# AQUATECH PARTS BULLETIN

This is an informational bulletin to help identify the Y-Strainers use on our truck mounted units.

**OBSOLETE A240026**

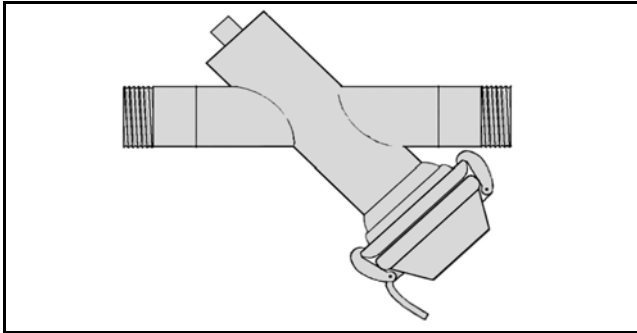
This is the original metal Y-strainer used by Aquatech, Inc. It was found on just about all truck mounted units (C-series, B-series, SJ, and SJR) up until the mid 90s. It featured 2½" male NPT threads and a camlock cap. The assembly is obsolete and must be retrofitted by A380819 or A380820.

**OBSOLETE A240027 & A380806**

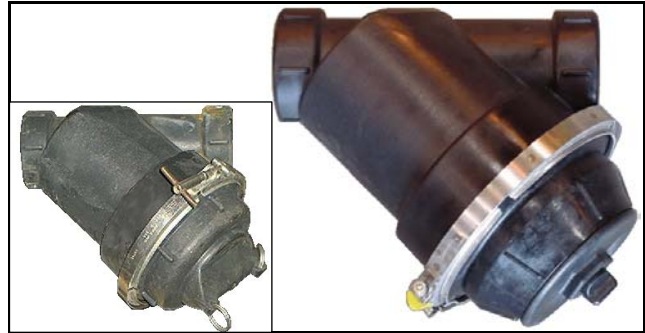
These 3"FNPT Y-strainer feature a stainless steel V-band clamp to hold the cap on. The earlier version of this strainer (p/n A240027 in the inset) had a T-handle nut on the clamp. The succeeding version (p/n A380806) utilized a locknut on the clamp and added a cap with a screw out outer cap to access the screen. Both of these are no longer available and are replaced by p/n A380820 below.
